**STAFF REPORT:** 10/12/2022 REGULAR MEETING

**APPLICATION NUMBER:** #22-8057

**ADDRESS:** 691 CANFIELD

**SCOPE:** REHABILITATE DWELLING, INSTALL PAVERS AT PATIO AND DRIVEWAY (WORK STARTED WITHOUT APPROVAL)

Figures 2 & 3, by Applicant, showing the rear basement site plan and elevation of proposed/completed work.

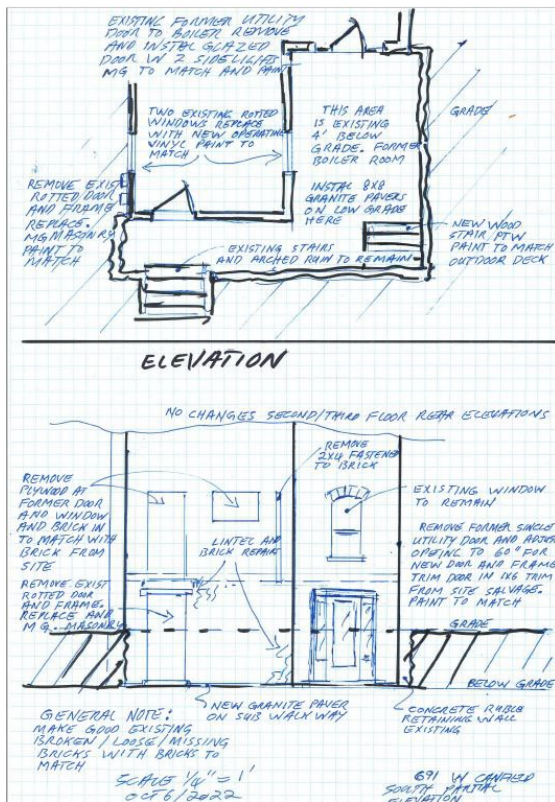
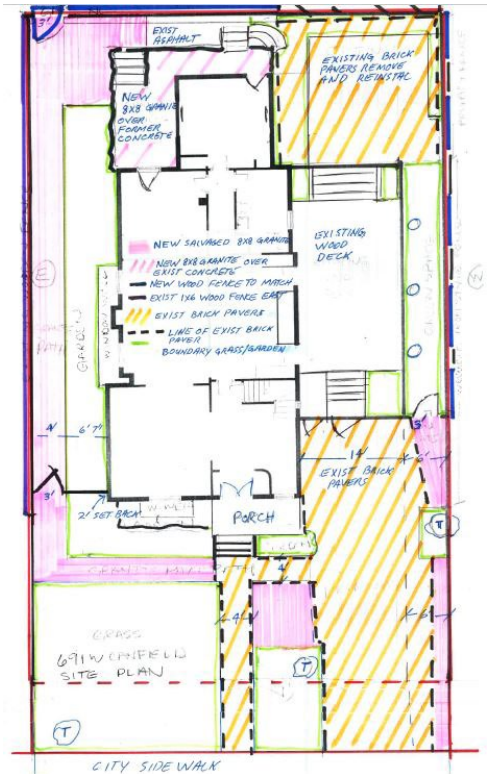
The applicant proposes to reconfigure the rear elevations by removing a recently intact rear porch, reconfiguring several openings, introducing a below-grade entrance to the basement at the former porch location, and installing a variety of new elements and textures in place of historic materials. The proposed work is general rehab of the house and installation of site features and consist of the following: replace asphalt shingles with asphalt shingles on porch roof, tuck point and replace existing or damaged brick with original matching brick as needed, repair chimney, paint trim reusing existing colors, replace windows and doors, replace windows and doors with brick infill, glass block or other material, add window wells, install two rear basement doors, regrade patio and driveway, reinstall brick driveway and walkways, install new paver walkways and patio, install metal and wood fences. Most work is in progress or complete without approval. (See attached drawings and details below.)

- the removal of stone set of steps that led to the single rear door (now covered with plywood) and resulting exposure of the basement walls has drastically altered the historic character of the home and its relationship to the site/rear yard. It is therefore staff’s opinion that all work proposed at the rear of the building walls within the footprint of the former porch is inappropriate. Rather, the applicant should erect a new porch of an appropriate style, design, scale and material at the location of the former porch so that the current basement walls are not exposed.

Staff therefore recommends that the Commission issue a Denial for the above work items, as it does not meet the

*Site Photo 8, by applicant, date unknown: (South) rear, facing east elevation showing before conditions of rear covered patio. Note the presence of stone steps leading to the now boarded-up door at the rear elevation.*

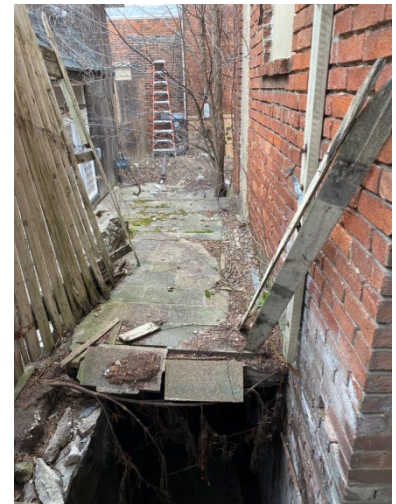
- It is staff’s opinion that the rear porch’s non-historic wood lattice overhang, wood fence enclosure and integrated flower bed were not historically contributing elements to the property and therefore merited removal. However, historically/as originally constructed, the home’s rear elevation possessed a masonry porch which obscured the basement walls and provided direct access to the first-floor doorways from grade. As previously noted, a review of the photos included with the home’s real estate listing indicated that this historic condition at the rear of the home was largely intact in late 2021/early 2022. The unapproved removal of the historic masonry porch (which led to the former paired doors, now enclosed with cedar shingles),

NORTH ELEVATION  
"FRONT"

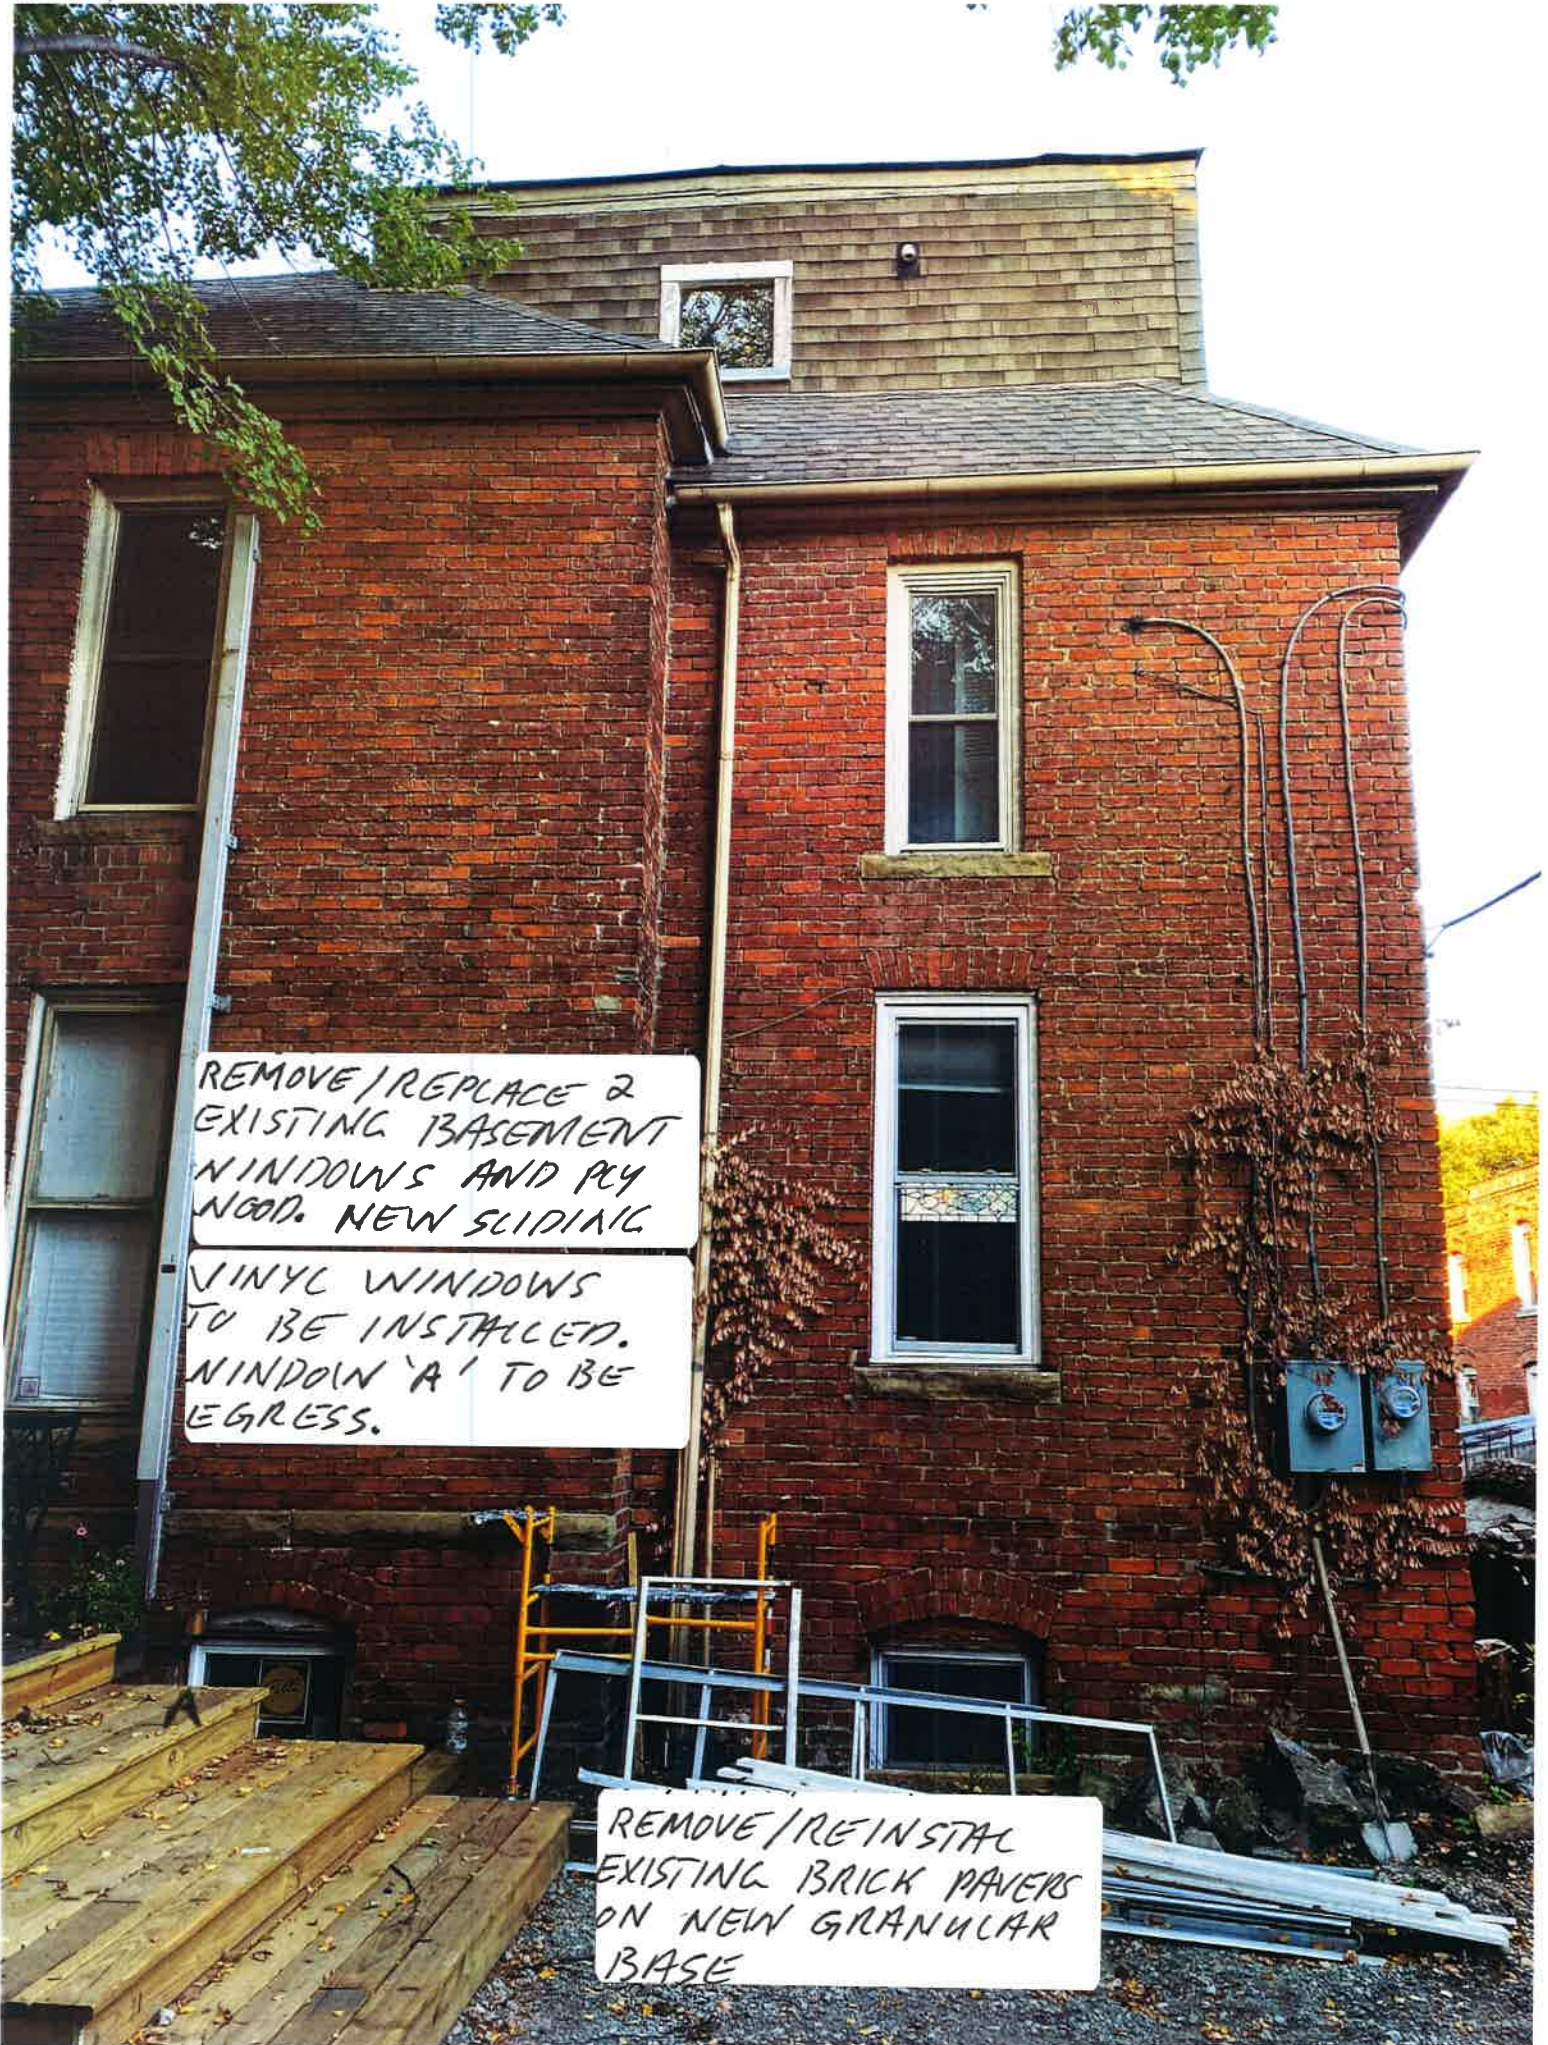
REMOVE EXISTING MOSS COVERED ASPHALT ROOF SHINGLES ON PORCH. REPLACE WITH NEW ASPHALT SHINGLES TO MATCH UPPER ROOF

REMOVE EXISTING SLIDING VINYL BASEMENT WINDOW LOWER SILL 10" AND PROVIDE NEW SINGLE HUNG VINYL EGRESS WINDOW

PROVIDE 6X6 PTW WINDOW WELL TO SUIT. REPLACE EXISTING WOOD TRIM TO MATCH.

6' METAL PICKET FENCE TO CLOSE OFF EAST SIDE YARD. GATED FOR ACCESS

SOUTH ELEVATION  
1 OF 3

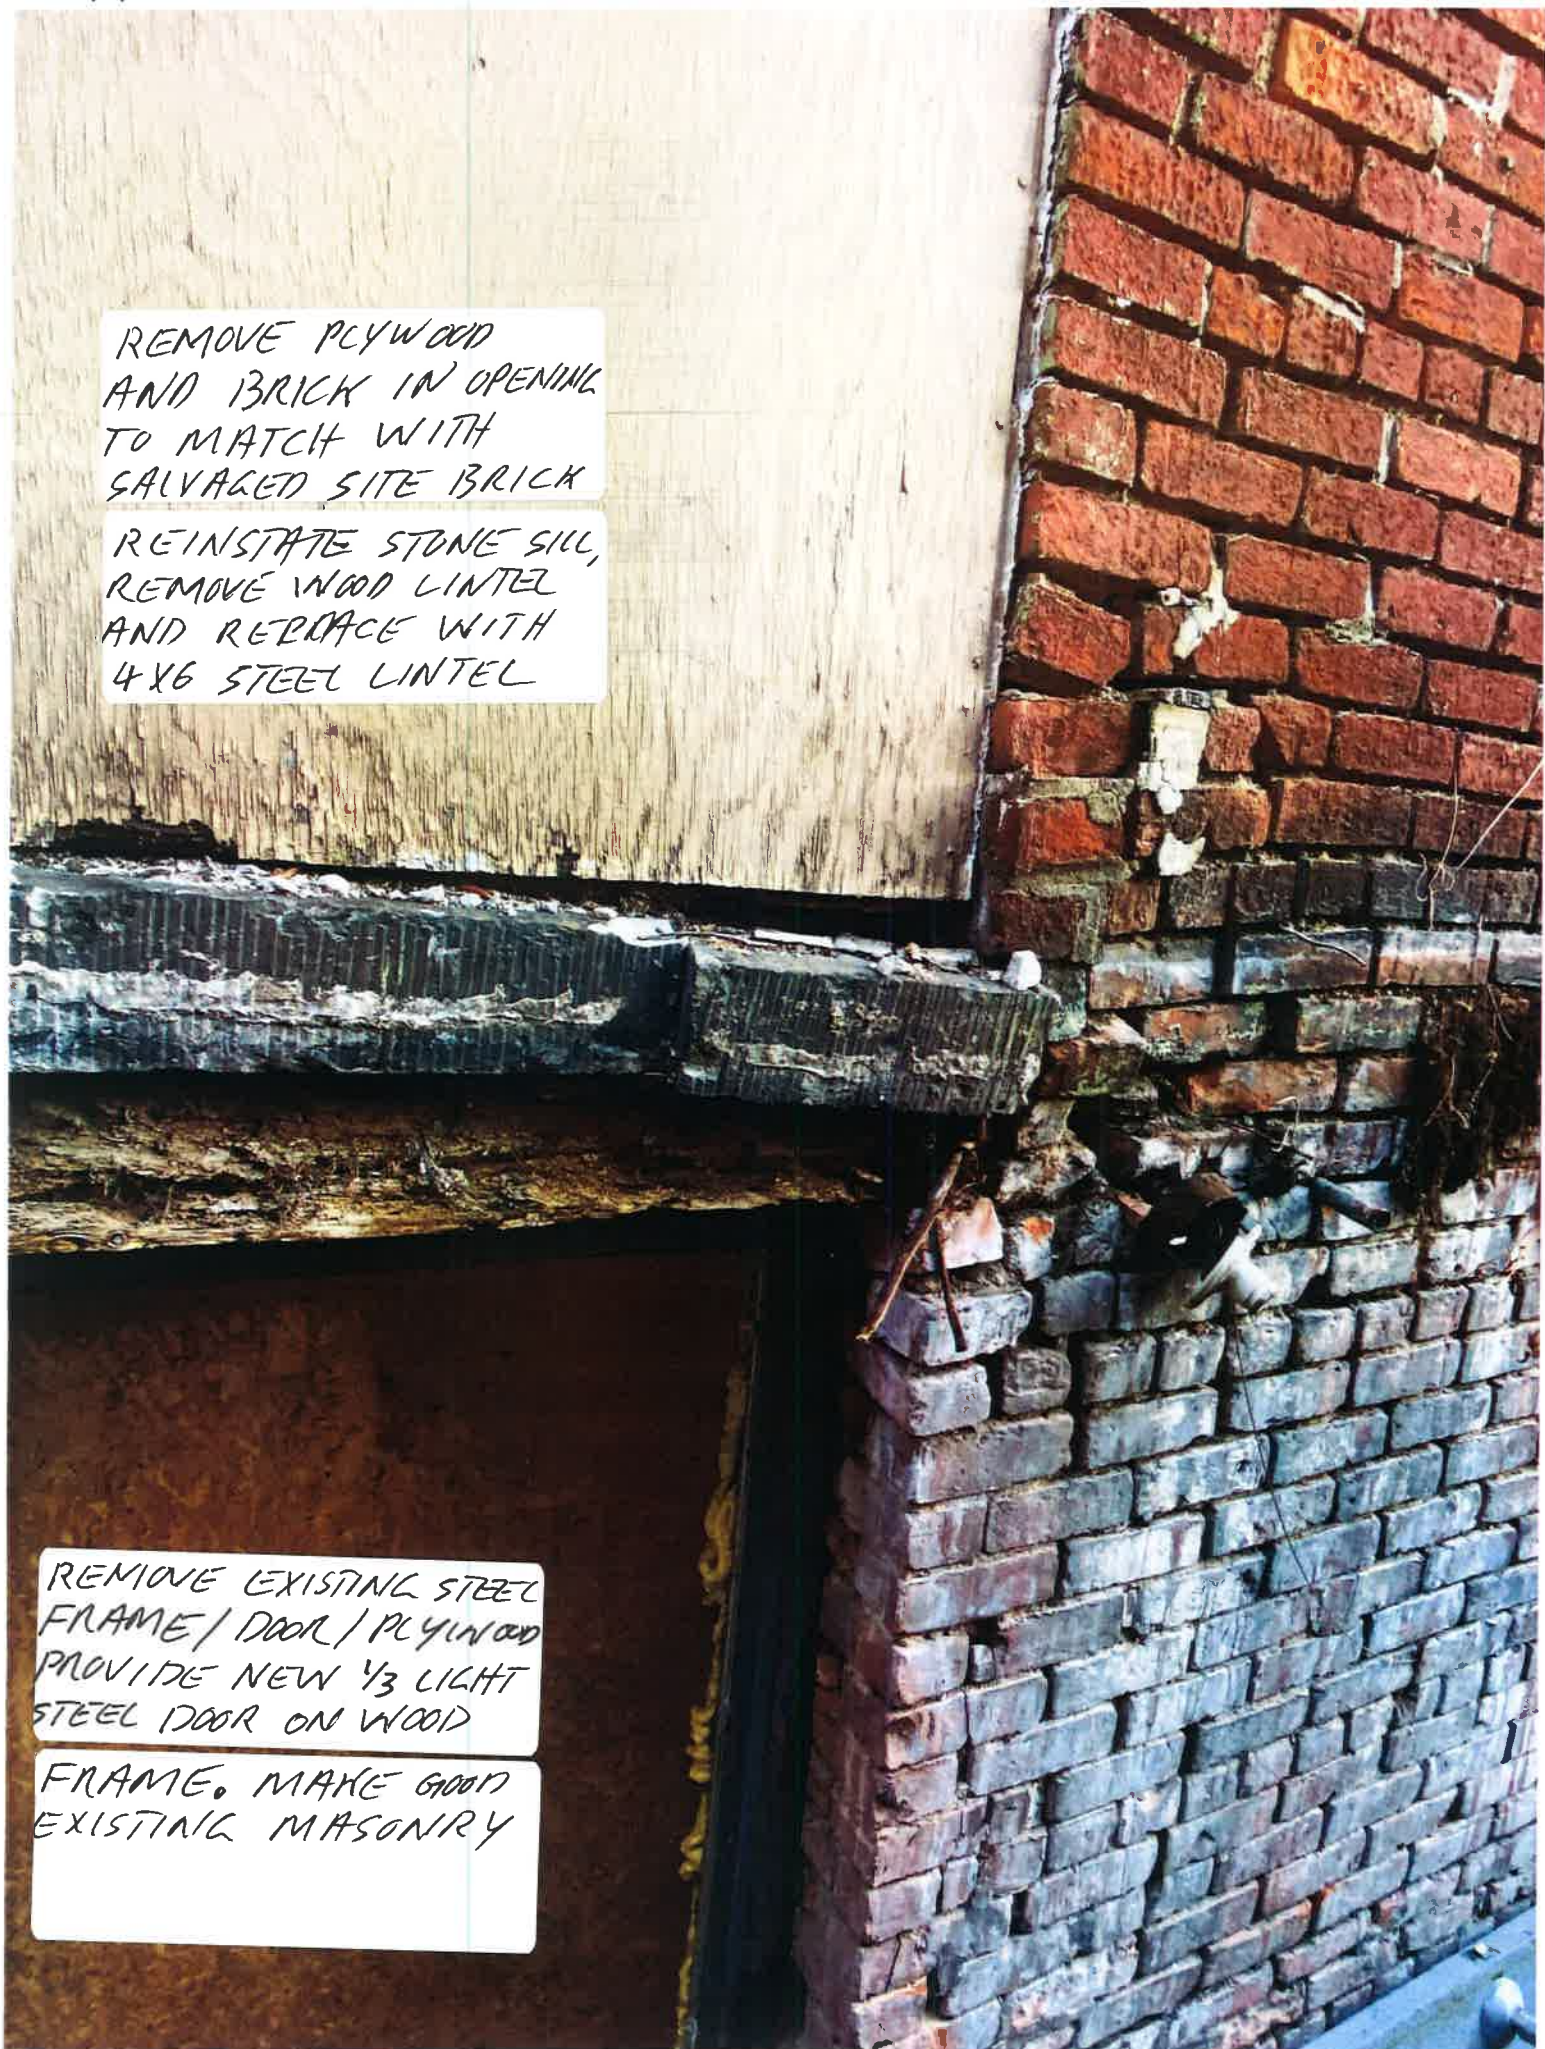
REMOVE PLYWOOD AT  
DOOR AND WINDOW.  
INFILL WITH EXISTING  
SALVAGED BRICK  
FROM THE SITE

EXISTING CONCRETE  
STAIRS AND RUBBLE  
STRUCTURE TO BE  
STABILIZED AND REMAIN

REMOVE PLYWOOD  
AND BRICK IN OPENING  
TO MATCH WITH  
SALVAGED SITE BRICK

REINSTATE STONE SILL,  
REMOVE WOOD LINTEL  
AND REPLACE WITH  
4X6 STEEL LINTEL

REMOVE EXISTING STEEL  
FRAME / DOOR / PLYWOOD  
PROVIDE NEW 1/3 LIGHT  
STEEL DOOR ON WOOD

EAST ELEVATION 2 OF 2

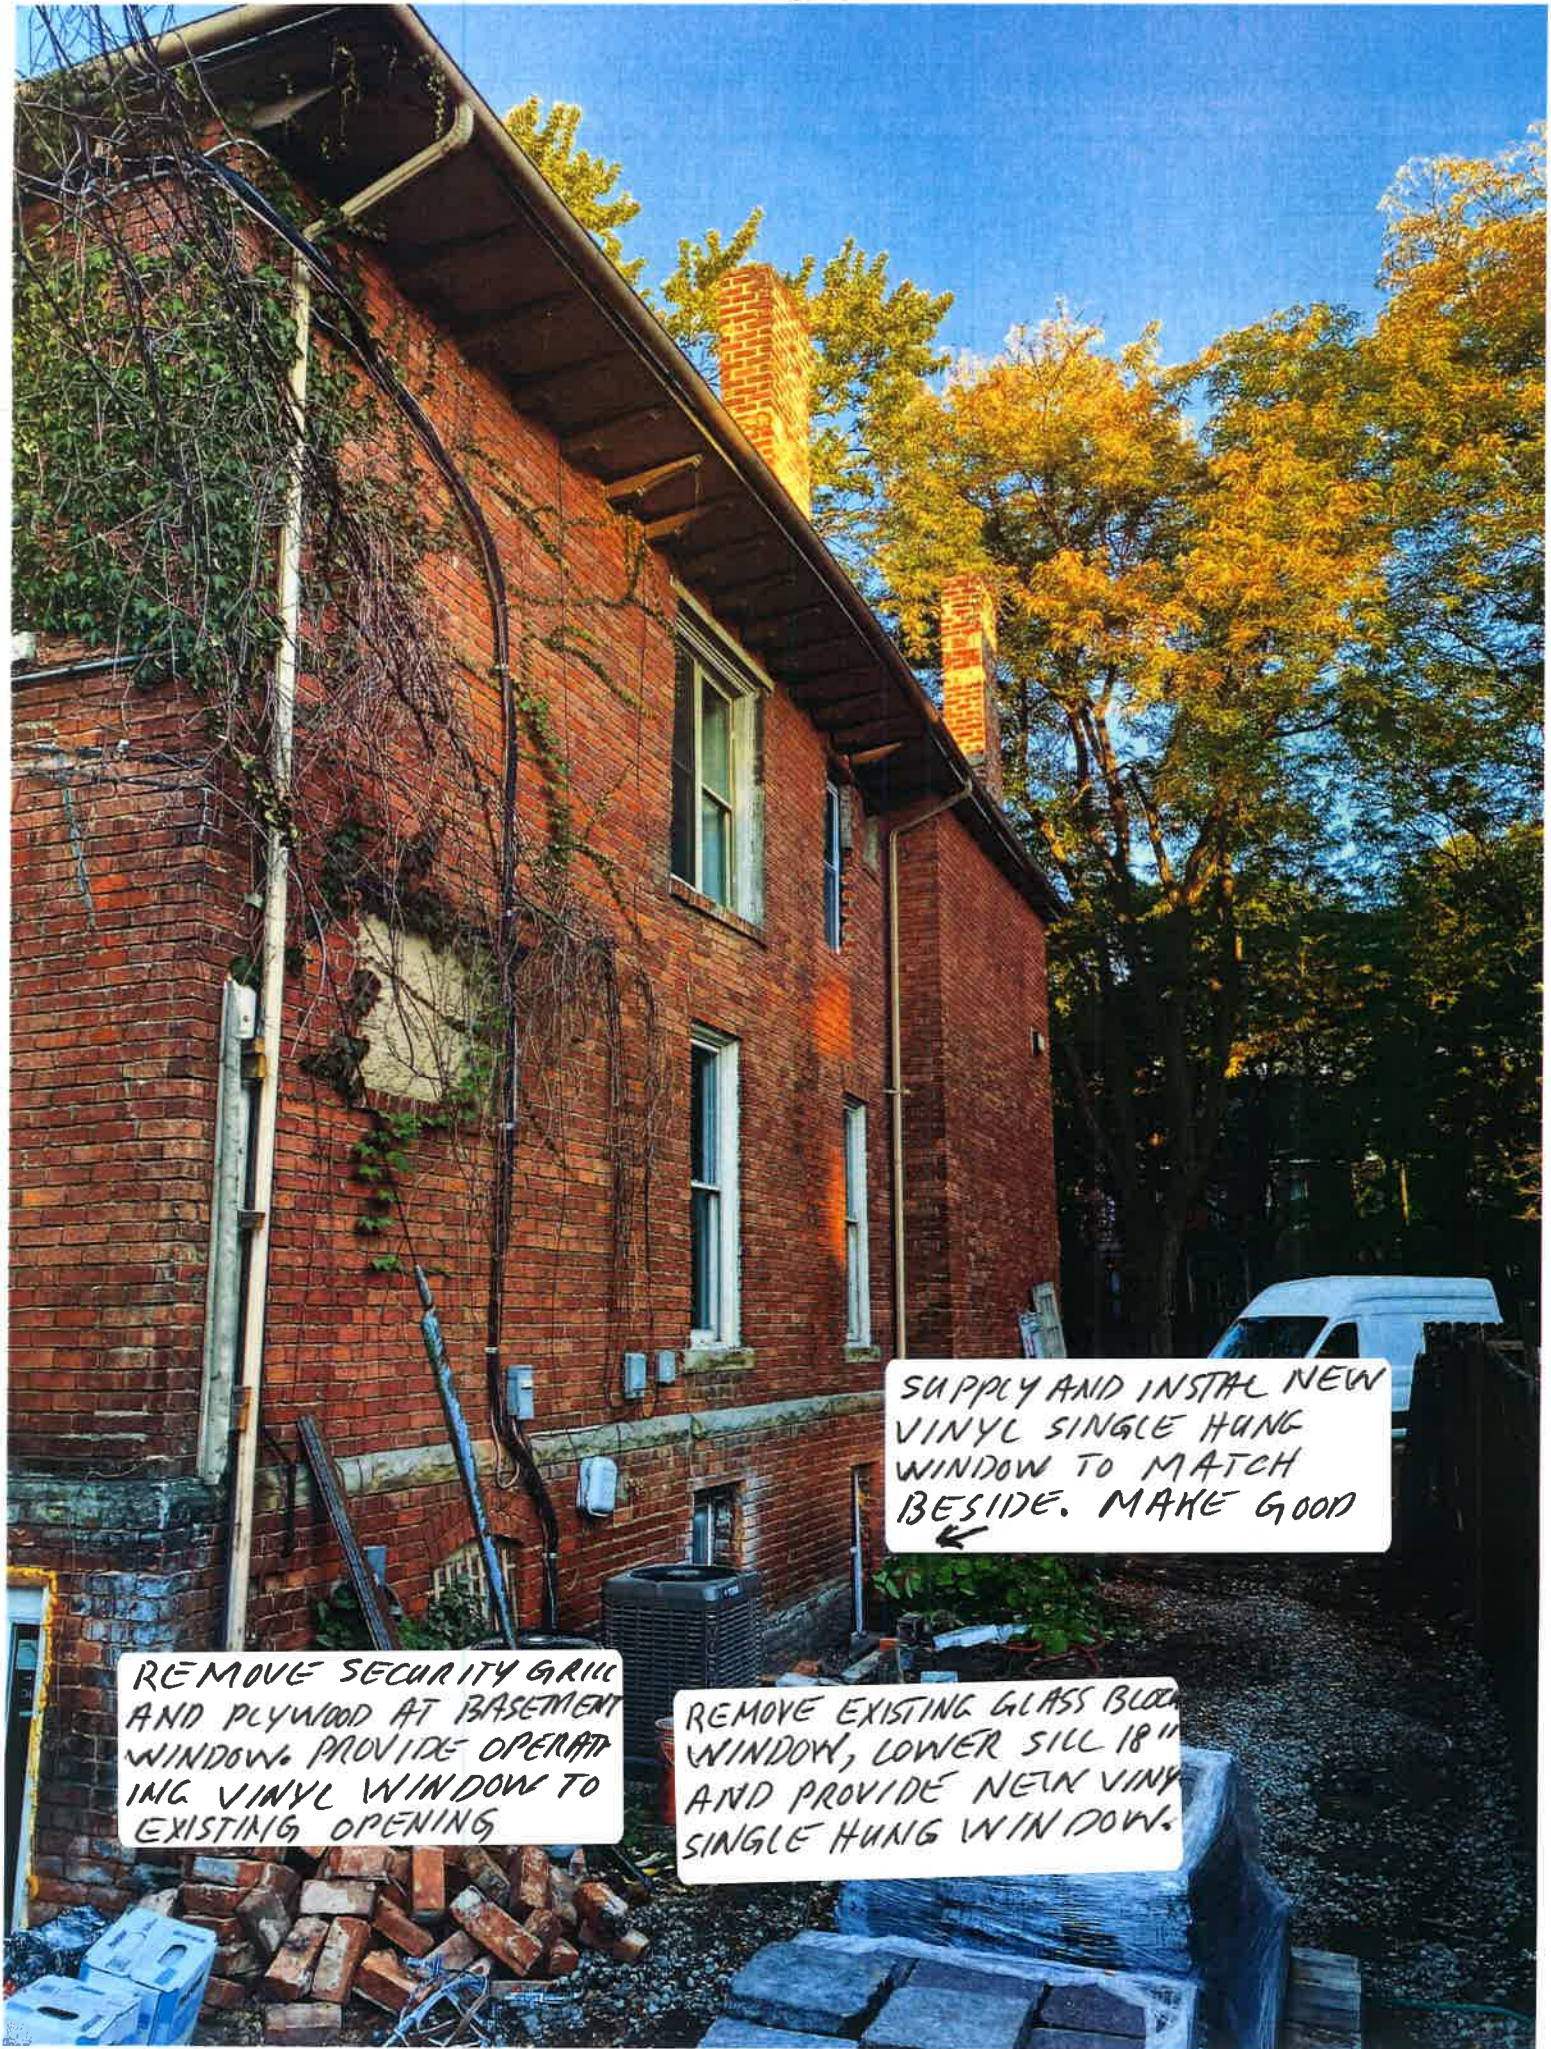
REMOVE PLYWOOD AND  
BRICK IN RIGHT SIDE  
WINDOW TO MATCH.  
EXTEND LEFT WINDOW

SILL DOWN 18" AND  
PROVIDE VINYL SINGLE  
HUNG WINDOW. MAKE  
GOOD MASONRY OPENING
